Type <b>Coffee Vending Machine</b>	Model <b>9100</b>	T.I. NO <b>04 - 2017</b>	
Serial Number <b>71412560</b>	Subject <b>NEW DOSING PIPE FOR POWDER CONTAINER</b>	ISSUED FOR (X)	Action Information <b>X</b>

# TECHNICAL INFORMATION JDE

**New dosing pipe**

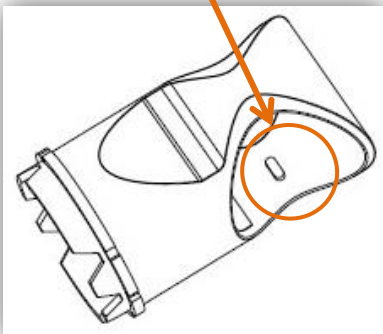
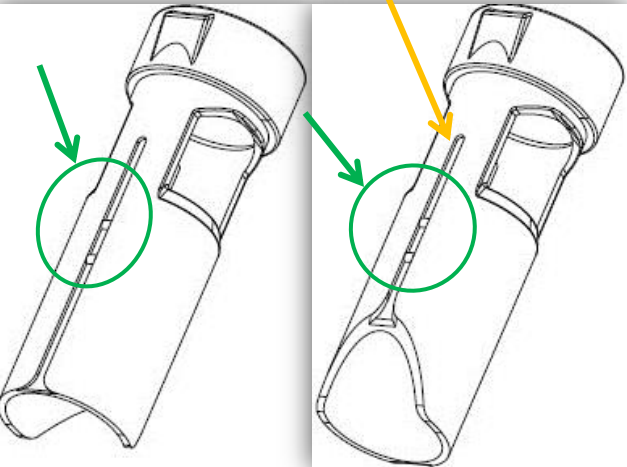
The **new** dosing pipes differ from the **pre-modification** dosing pipes for the introduction of two stroke stops.

**Modification:**  
*Two stops* have been added along the two tracks.  
 The two stops work with the stops of the **spout**

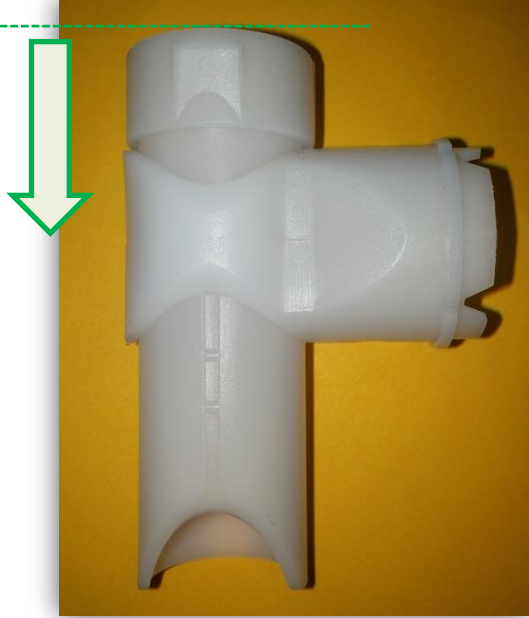
Dosing pipe in **low position**  
Delivery of the powder *allowed*

Dosing pipe in **high position**  
Delivery of the powder *not allowed*

In this position the **stops**, added along the two tracks, avoid any accidental removal of the **dosing pipe** from the **spout**

*New solution 1,5 L container assembly :*

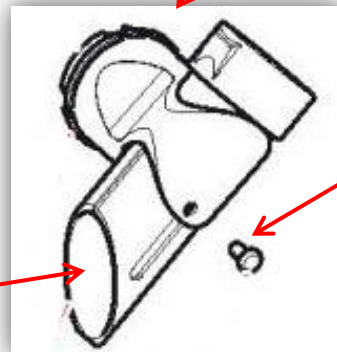
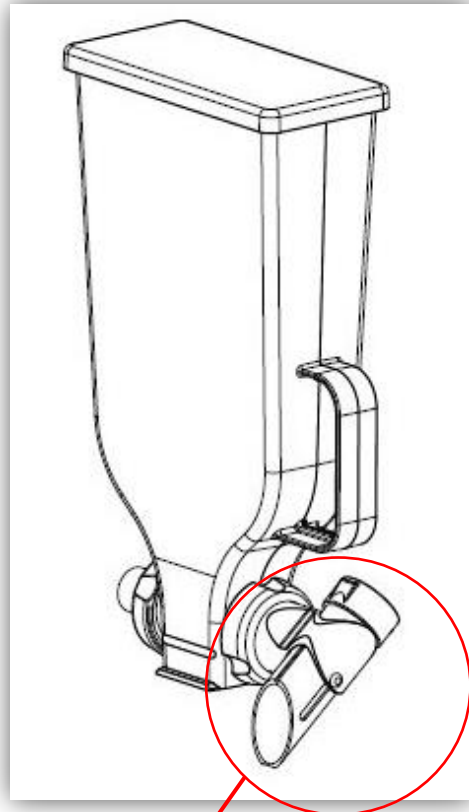
the **plastic rivet**, used to remove (or assemble) the *pre-modification* dosing pipe from (with) the **spout**, has been removed.
